Greater Avalon Employment Precinct (GAEP)

Date:	11 December 2025
Attention:	Victorian Planning Authority
Project:	Greater Avalon Employment Precinct / draft Amendment C477ggee
Purpose:	Submission on behalf of Avalon Ind 1 Pty Ltd - 15 Avalon Road, Avalon

Figure 1 – Draft Schedule 50 to Clause 43.02 – Plan 1

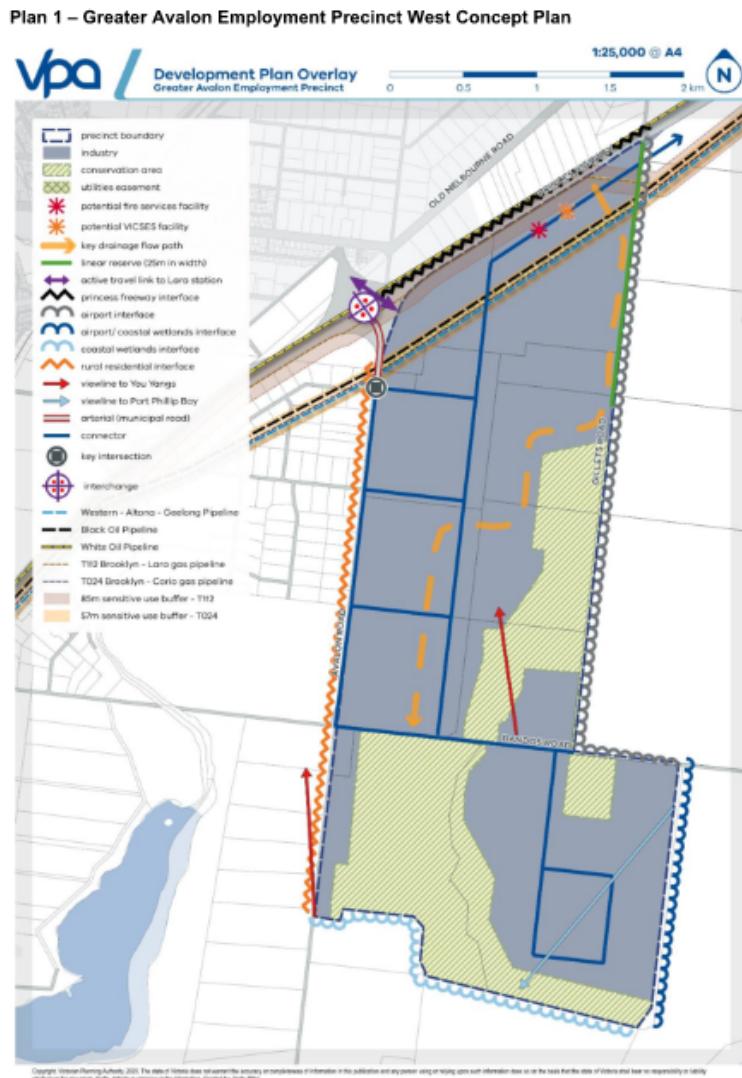
- The 'active travel link to Lara station' on Plan 1 should be deleted. The designation is located outside the Amendment area and the supporting documentation does not provide sufficient detail of what is proposed or how it may be implemented via the Development Plan;

- The road network on Plan 1 does not provide equitable access to the Subject Land, with access reliant on delivery of internal connector roads through other land holdings. The identification of an ingress / egress point to the subject site direct from Avalon Road should be identified on Plan 1, as shown on the ADC concept plan. The access is critical to the initial development of the Precinct and the viability of the Subject Land to be developed independently of the MAB land holding and promote economic activity within the Precinct.
The access should be included on the Plan 1 and within the Schedule and should be fully operational. Traffic engineers, Ratio, have undertaken design and assessment of the proposed access arrangements in this location having regard for the proximity with the round-a-bout and freeway offramp to the north west of the Subject Land. A concept for access is provided within the Transport Assessment memo, prepared by Ratio.

- The inclusion of 'interface' notations on Plan 1 should be deleted as their purpose or implementable basis is not established within the draft Schedule to the DPO. It is implicit in the Greater Geelong Planning Scheme that future use and development must respond to context, including interface conditions that apply to an application area;

- Further details of the need for the provision of the potential fire services facility and potential VICSES facility (including land area requirements) on the Subject Land should be provided, as shown on Plan 1. In our view these facilities should be relocated to have direct access to Avalon Road where access to the external road network is available to serve the wider area.

- Clarification of the implementation, delivery responsibility, embellishments and/or other infrastructure to be included in the Gillett's Road 'linear reserve' as shown in Plan 1 is required in the draft Schedule to the DPO;

The concept plan does not nominate vehicle access to the 15 Avalon Road land other than through the future north-south connector road.

- The road network on the concept plan does not provide equitable access to the 15 Avalon Road land, with access reliant on delivery of internal connector roads through other land holdings. How this would be resolved is not clear noting that connector roads (land or construction) are not typically shared infrastructure items within greenfield development areas.

Figure 2 – Interim Avalon Road Southern Interchange Roundabout Concept

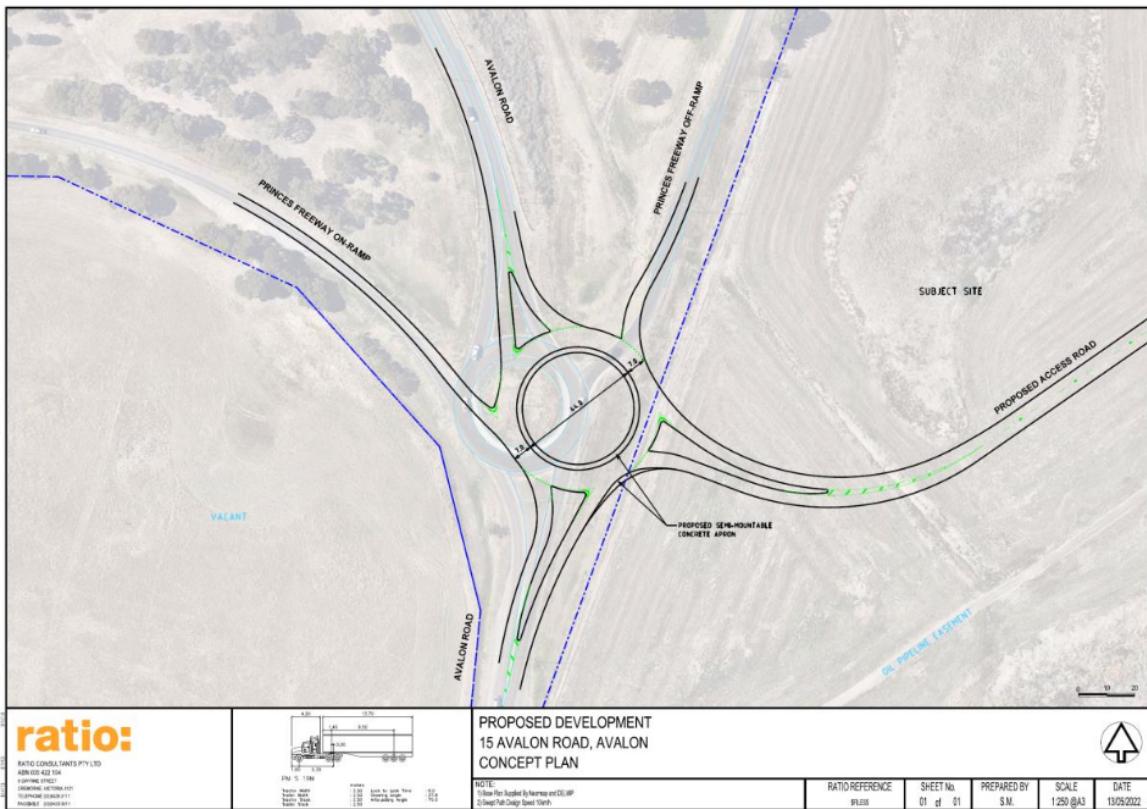
As per our previous advice, we are of the view that direct access to the 15 Avalon Road land is possible with an option to achieve this being through the upgrade of the existing roundabout (see Figure 2 below).

- Direct access to the 15 Avalon Road land from the interchange would reduce ultimate volumes on Avalon Road to the south and likely remove the need for duplication of the northern section of the road on the basis that:

- Upgrade of the southern interchange intersection to support duplication of Avalon Road duplication will require a dual lane roundabout or duplication signalised intersection.

- Both options would result in a more complex intersection upgrade and likely required substantive reconstruction of the southern side of the interchange and additional land take to match to the existing overpass and on / off ramps.
